**LOG OF MEETING
DIRECTORATE FOR ENGINEERING SCIENCES**

SUBJECT: Standards Technical Panel for Door, Drapery, Gate, Louver, and Window Operators and Systems (UL 325).

DATE OF MEETING: August 23, 2001

SUBJECT: Standards Technical Panel Meeting Agenda

Figure 25.1
Critical condition flow chart for residential garage door operator entrapment protection devices and functions

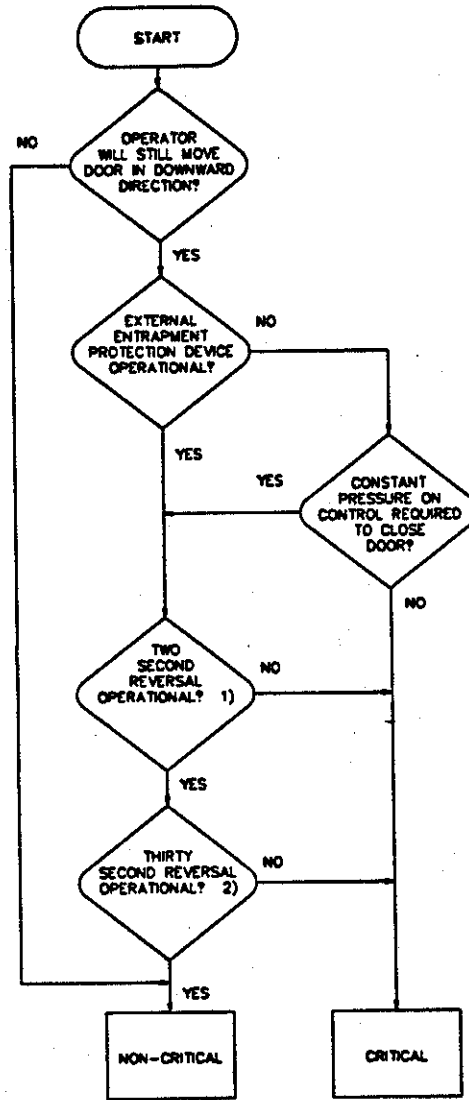
UL has been requested to clarify that those component failures, which result in a shutdown or inoperative unit before a full cycle of travel is completed, are considered non-critical. Therefore, UL is proposing to revise the notes to Figure 25.1 and revise paragraph 25.8 for clarification.

If the fault in a component results in a shutdown or inoperative unit (any case in which the operator will not complete a full cycle, open and close, of travel) the component is considered non-critical.

Exception: If the fault in a component results in a shutdown or inoperative unit (any case in which the operator will not complete a full cycle, open and close, of travel) the component is considered non-critical.

(NEW)
Figure 30A.1
Type A Entrapment Protection Device

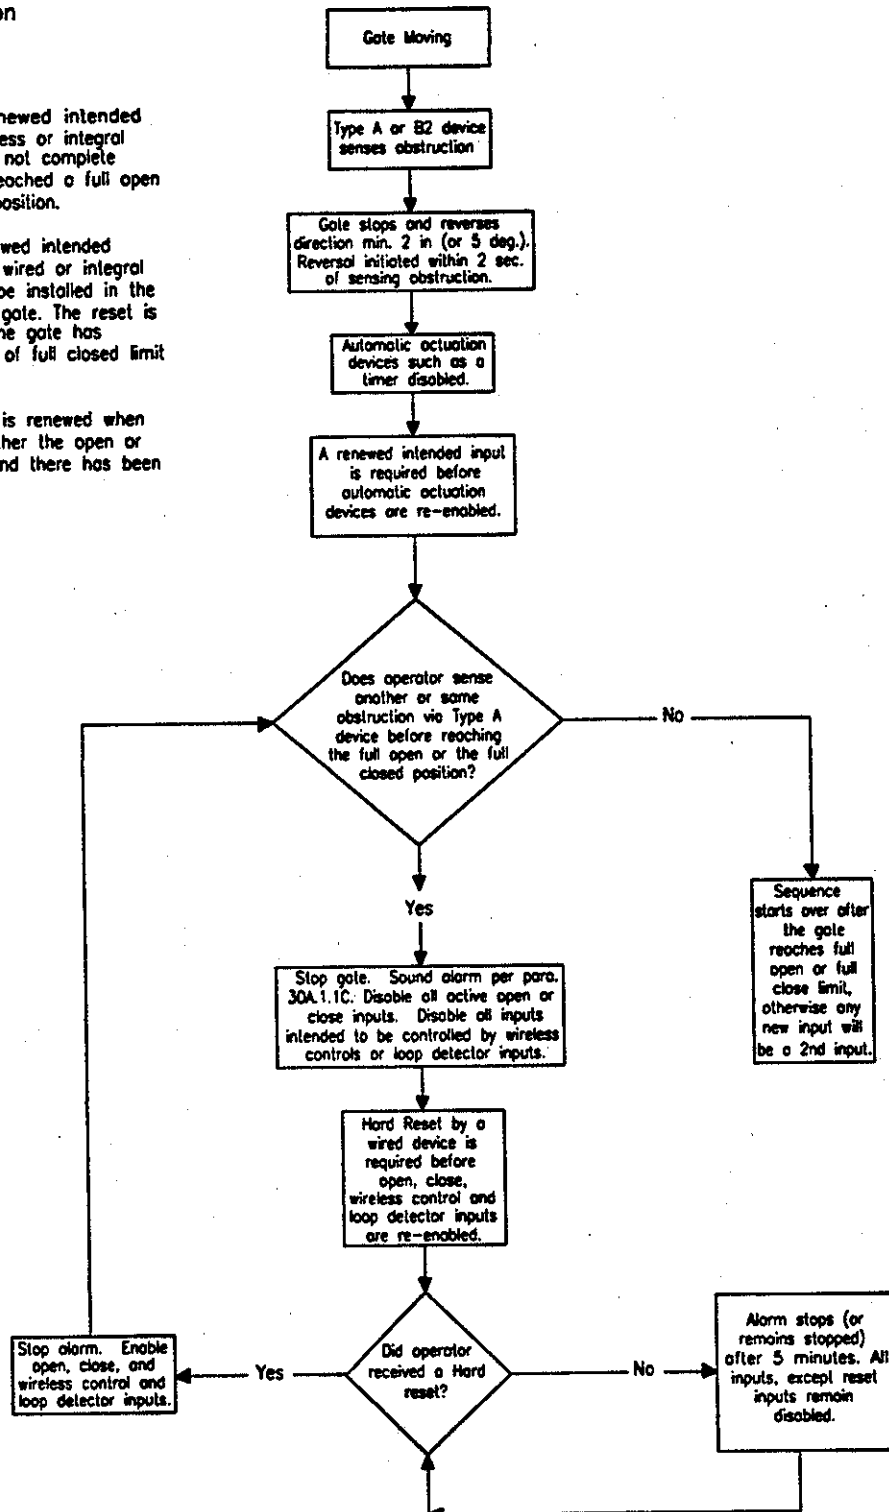
Since the functions of the entrapment protection devices are complicated, manufacturers have requested flowcharts be included in the standard. The flowcharts would provide information dealing with linkage of the entrapment sensors and certain wireless controls and the inputs that were previously active. Therefore, UL is proposing to add Figures 30A.1, 30A.2, and 30A.3 to further clarify the functions of Type A, B1, and B2 entrapment protection devices.

SOFT RESET = Renewed intended input via wired, wireless or integral control. The reset is not complete until the gate has reached a full open or full closed limit position.

HARD RESET = Renewed intended input via a manual, wired or integral control intended to be installed in the line of sight of the gate. The reset is not complete until the gate has reached a full open or full closed limit position.

Note: The sequence is renewed when the gate reaches either the open or close limit device, and there has been a reset.

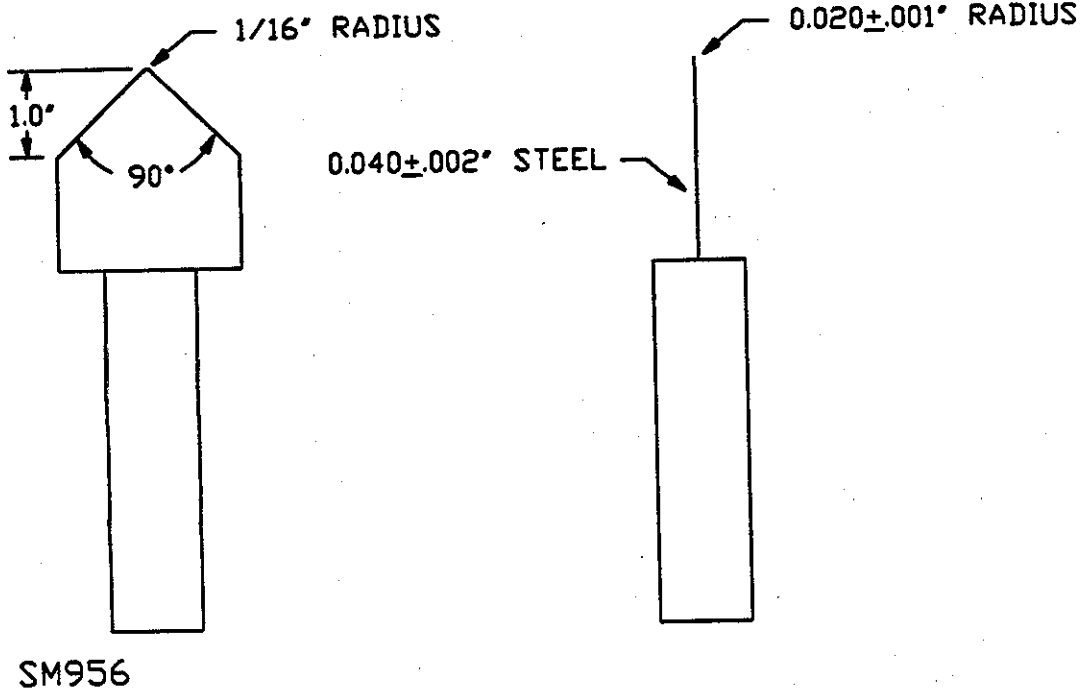
Paragraph 33.1A.1 references paragraph 33.1.2 for the obstruction used for the test. The requirement in paragraph 33.1.2 and Figure 33.1 relates to garage door operators and UL has determined that its application to gates is not clear. Some Authorities having Jurisdiction have made interpretations that the photoelectric beam for gates must be located not more than 6 inches from the ground based on this requirement. This would not provide the intended protection for the gates covered by paragraph 33.1A.1. UL is proposing a new paragraph, 33.1A.2, to clarify the requirements for testing a swing gate and a sliding gate.

33.1A.2 The obstruction used for the test is to consist of a white vertical surface, 27-1/2 inches (698 mm) high by 12 inches (305 mm) wide. The obstruction is to be placed on the ground in accordance with 31.1A.1.

(PROPOSED)
Figure 47.1
Puncture probe

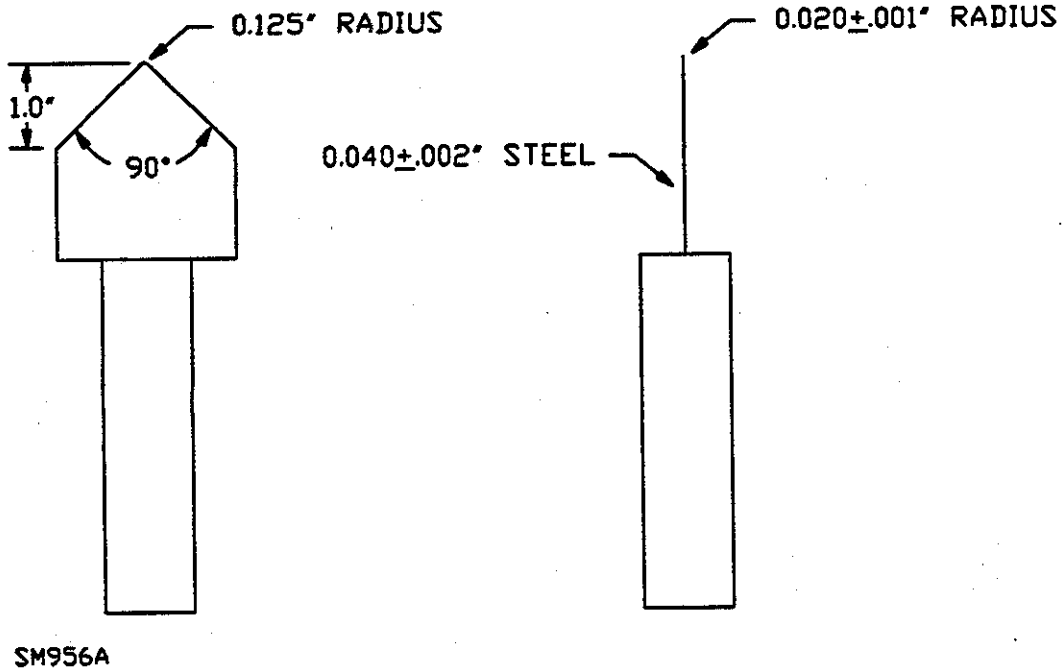
Representatives of industry have requested a change in the radius of the puncture probe shown in Figure 47 from 1/16 inch to 1/8 inch to provide for edge sensors with a lower activation force and greater sensitivity due to having thinner extrusion walls. By increasing the probe radius, the edge sensor wall thickness is reduced by 20-25 percent. The 20-pound force used on the puncture probe would remain unchanged. Therefore, UL is proposing to revise Figure 47.1 to reflect the increase in the probe radius.
